RESTRICTIVE COVENANT AMENDMENT REVIEW SHEET

CASE: C14-91-0015(RCA)
Champion Commercial Development

Date: April 12, 2011
To: Clark Patterson, Case Manager
CC: Kathy Hornaday, P.E., PTOE
HDR Engineering, Inc.
Reference: Champion Commercial Development, C14-91-0015(RCA)

Sight Distance Calculations

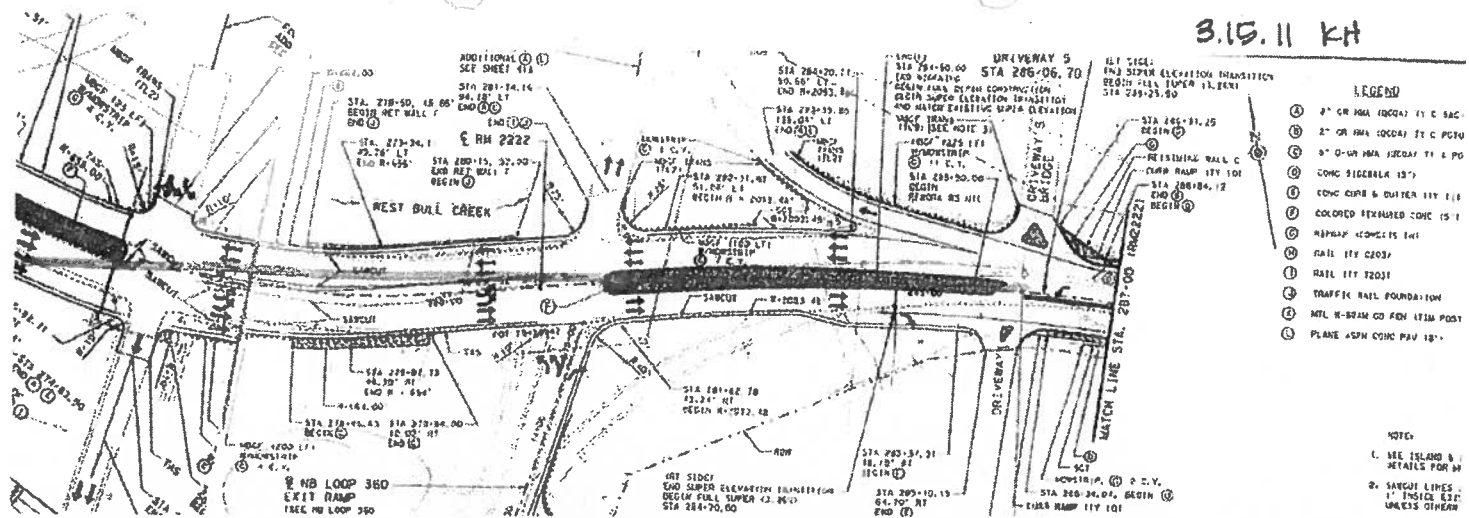
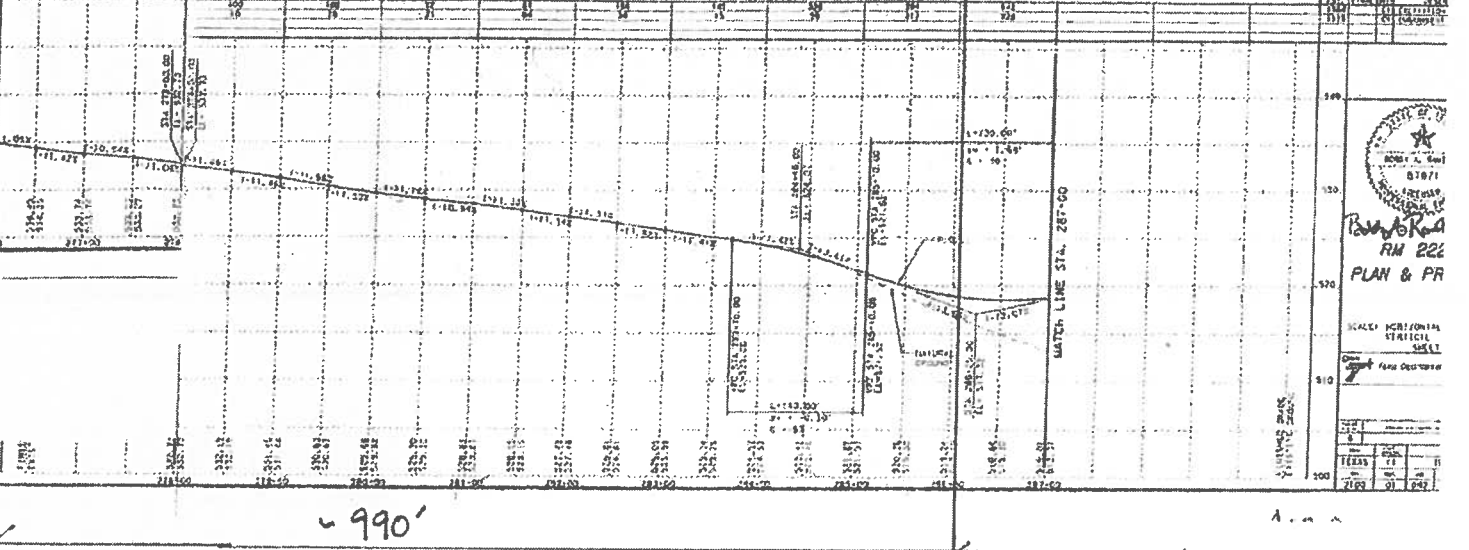
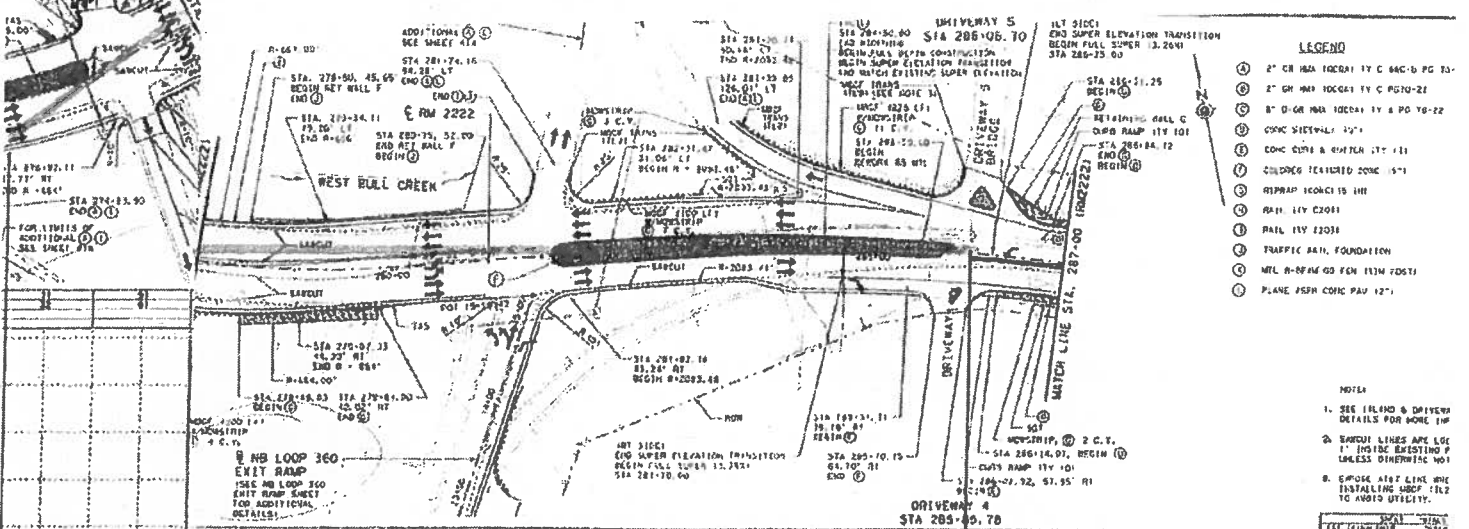
- SIGHT DISTANCE REQ'D FOR RIGHT TURN FROM A STOP, WITH 55 MPH DESIGN SPEED = ~~445~~ 530 FT
- SIGHT DISTANCE REQ'D FOR LEFT TURN FROM MAJOR STREET, WITH 55 MPH DESIGN SPEED = 445 FT
- SIGHT DISTANCE REQ'D FOR HILL COUNTRY ROADWAY = 550 FT

990' > 550' ∴ ADEQUATE SIGHT DISTANCE

Figure 1
RM 2222 Proposed Lane Configuration

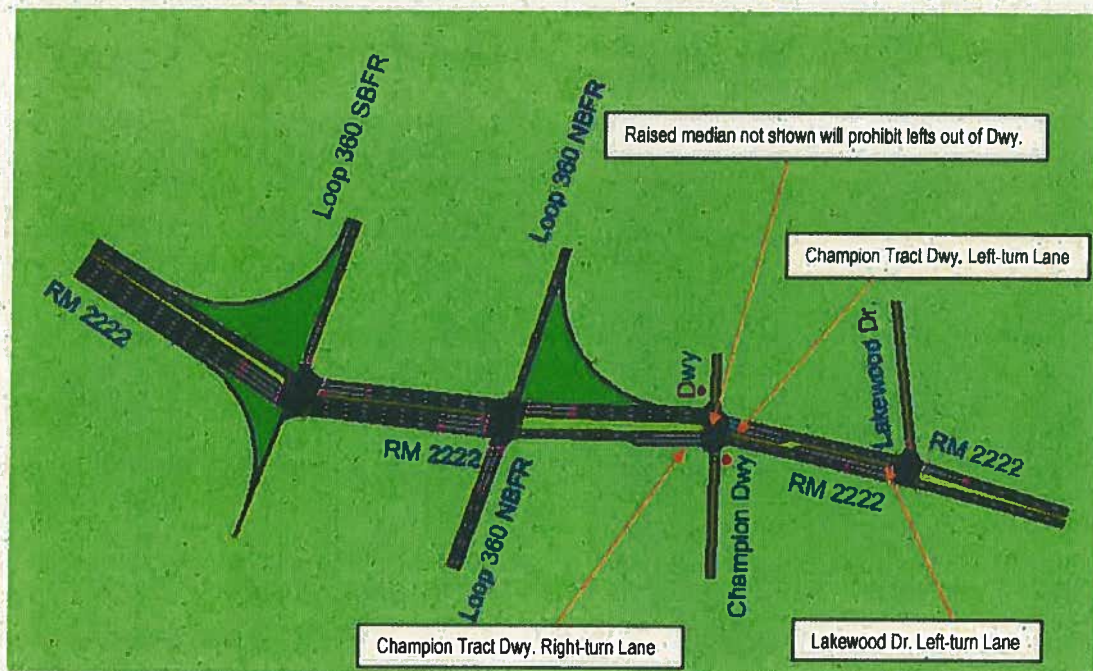
As shown in Figure 1, the Champion Tract driveway on RM 2222 will be aligned with an existing driveway to a retail center on the north side of RM 2222. This driveway is a right-in/right-out only driveway. Counts were not available for this location; therefore, traffic to and from this retail center was estimated given the land use present on the site, which includes 14,600 square feet of quality restaurant, 8,330 square feet of high turnover restaurant, and 4,070 square feet of shopping center. (Trip generation information is enclosed.) The retail center also has an access driveway (not depicted) on Loop 360 Northbound Frontage Road, north of RM 2222. For clarification, the 2007 turning movement counts used for this analysis do include traffic generated by this retail center, since it was occupied at that time; however, counts for the driveway itself are not available. Therefore, traffic from this retail center was not added to the intersections listed above.
